ORIGINATION FORM

Proposed Revisions to a Standard Plans Index
(Please provide all information – Incomplete forms will be returned)

Index Number: 460-470
Sheet Number (s): 1
Index Title: Traffic Railing- (Thrie-Beam Retrofit) Typical
Details & Notes

Summary of the changes:

LAST REVISION 11/01/19	REVISION	DESCRIPTION:	 FY 2020-21 STANDARD PLANS	TRAFFIC RAILING - (THRIE-BEAM RETROFIT) TYPICAL DETAILS & NOTES	INDEX 460-470	SHEET 1 of 3
---------------------------	----------	--------------	--	--	------------------	-----------------

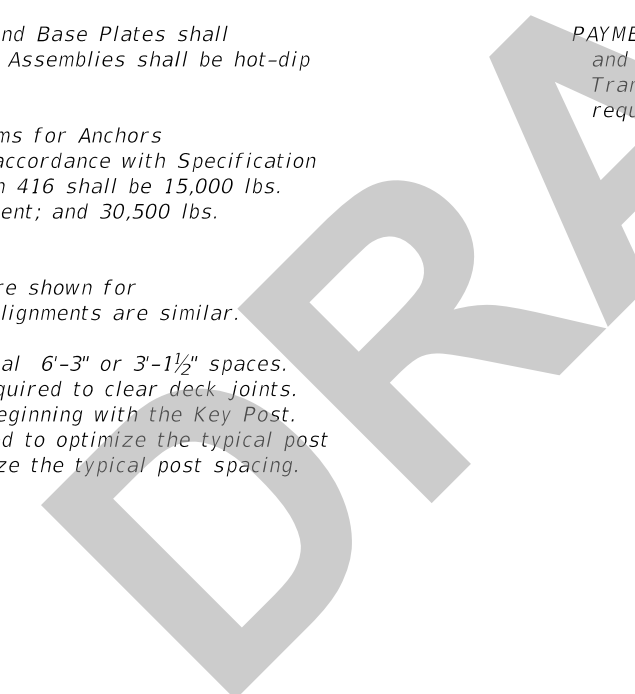
Changed Barrier Delineator note

Consistency with other traffic railing indexes.

BARRIER DELINEATORS: Install Barrier Delineators at the top of the guardrail offset blocks in accordance with Specification Section 705. Match the Barrier Delineators color (white or yellow) to the near edgeline.
